# Technical Data Sheet

## Bennington 8350 Front Door Latch Upgrade

*Kit #93-73501*

**Publish Date: 5/31/2006**

**Exploded view of new parts.**

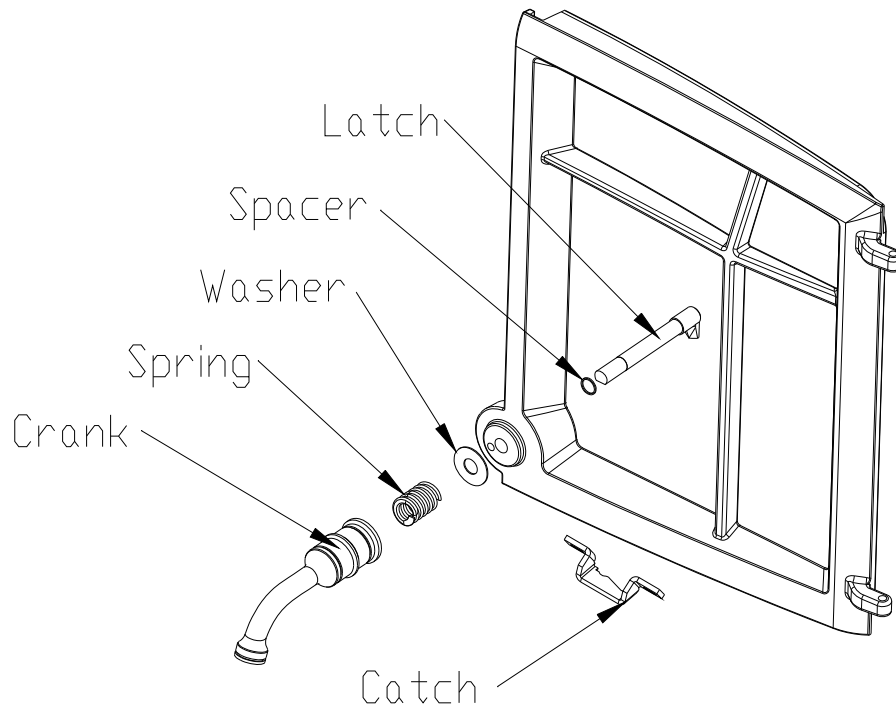
**IMPORTANT NOTE FOR STOVES BUILT PRIOR TO SEPTEMBER 2005:** If the stove was manufactured prior to September 2005, (any serial number below 3115), you will need to install the new front door latch keeper, part number 5350-062, along with this latch kit assembly.

**🔥 Note:** If the stove has a serial number that is higher than 3115, proceed to step 4.
- 2) For stoves with a serial number below 3115 (manufactured prior to September 2005), remove and discard the front door catch by removing the two Phillips head screws (retain screws).

- 3) Install the new catch (#5350-062) using the screws removed in step #2.
- 4) Place one of the steel spacers on the threaded door latch (add or subtract spacers to fine tune the fit – see step 6). Push the latch through the door; place the large washer and coil spring onto the latch, and thread the chrome crank onto the latch until it is within 1/8" of the face of the door (see illustration on page 2 for part locations).
